The Kerala Industrial Corridor Development Corporation Limited (KICDC)

Name of Work: Design, Construction, Testing, Commissioning and Operation & Maintenance of Infrastructure Works at Pudussery Central & Kannambra of Palakkad Node in Kerala under extension of Chennai Bengaluru Industrial Corridor (CBIC) to Kochi via Coimbatore "On EPC Basis"

Tender Notice No:TKI/IMC/EPC/01/2025-2026, **Dated:** 13th May 2025

Responses to Pre-Bid Queries

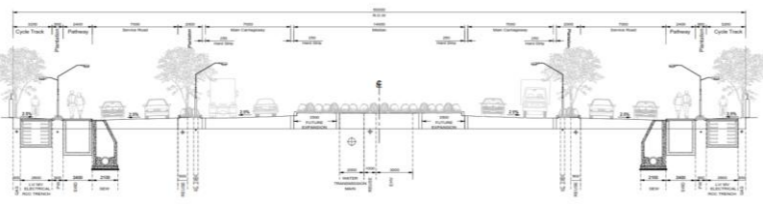
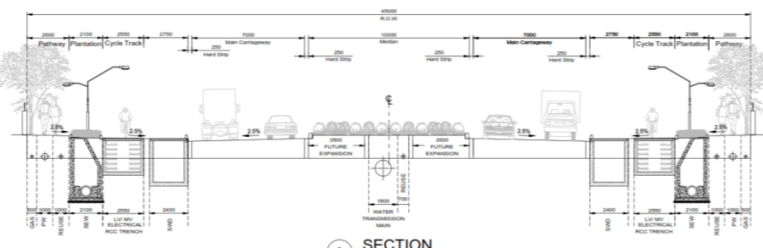
114.	A. Technical Scope & Design Queries	Road Design:	Kindly confirm if the 30m, 24m, 18m, 15m, 12m, 9m ROW cross-sections are final and approved. Can bidders propose alternate typical cross sections and design during value engineering?	The details provisioned in the cross sections are minimum requirement of the project. Contractor can alter the cross sections without changing the cross section typology complying to the tender conditions and same shall subject to approval of engineer in charge during construction.

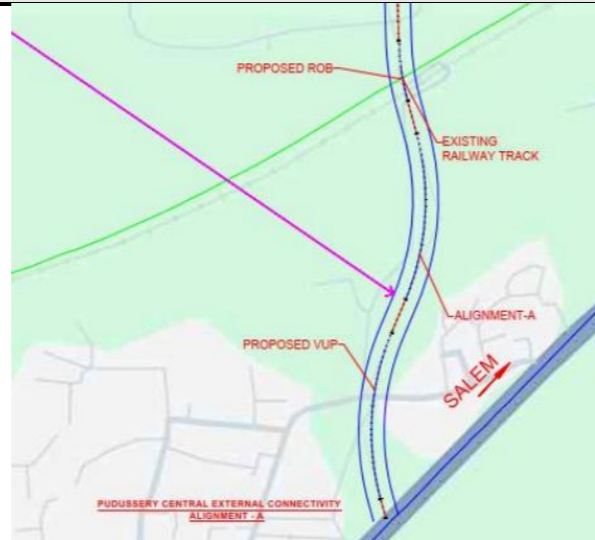
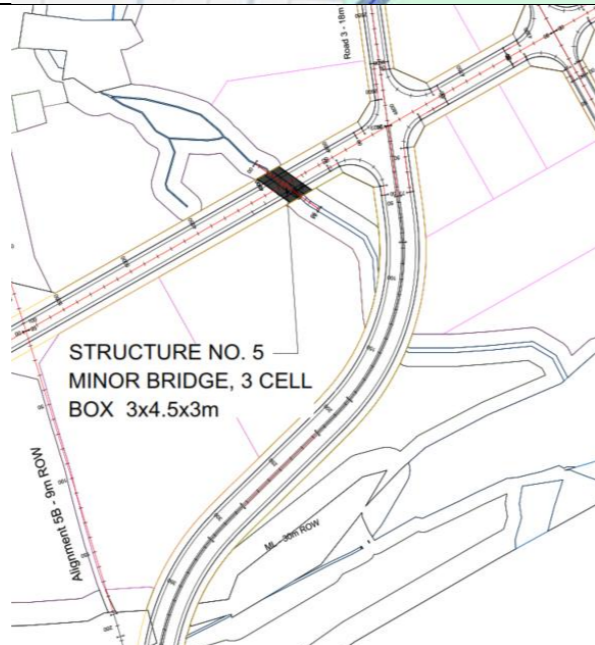
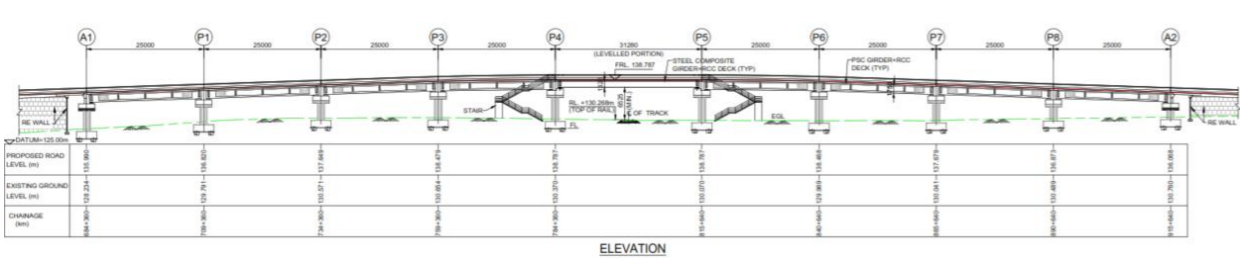
133.	General	The length of roads is a minimum requirement and may vary as per detailed engineering design.	No of bus bays and shelter are not provided	The contractor will finalize the numbers and locations of bus bays and shelters during the detailed design stage of EPC.

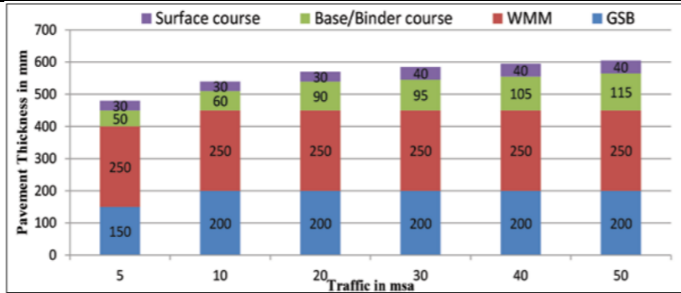
151.	Volume : 02 -TECHNICAL SPECIFICATION 1.7 Field Laboratories	Arrangement can be made by the Contractor to have the cubes tested in an approved laboratory in lieu of a testing machine at site at his expense, with the prior consent of the employer.	Please confirm NABL approval is not manadatory for the third party lab and contractor have the freedom to use any reputed labaoratory having previous reference with government infrastructure projects.	Tender conditions shall prevail. All the material testing shall be conducted through NABL approved laboratory.
